**RESPONSE TO INFORMATION REQUEST – MATERIAL CHANGE OF USE – HOUSE
AND HOME BASED BUSINESS (BED & BREAKFAST) – CAPE TRIBULATION ROAD,
DIWAN – LOT 41 ON RP739765**

In accordance with Section 278 of the *Sustainable Planning Act 2009 (SPA)*, please find outlined below our response to Council's Information Request dated 16 September 2013.

ONSITE SEWERAGE ASSESSMENT

**LOT 41 (RP739765) CAPE TRIBULATION ROAD
COW BAY**

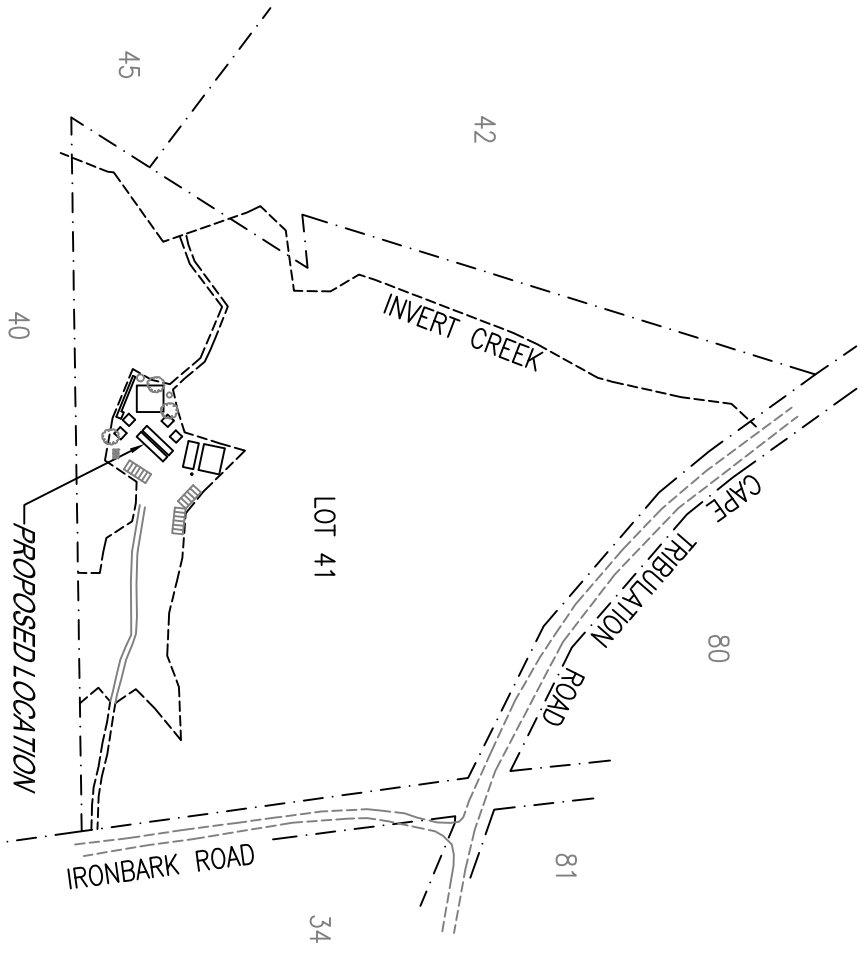
1. *Provide a full On-Site Sewerage Disposal Report prepared in accordance with the FNQROC Development Manual. Amongst other things, the report should nominate clearances to boundaries and watercourse and location of reserve area.*

The attached report outlines the proposed on-site waste treatment method along with separation distances to boundaries, watercourse, buildings on site and other matters.

The land application area shown on Figure 1, Appendix A meets all recommended horizontal separation distances for advanced secondary effluent quality.
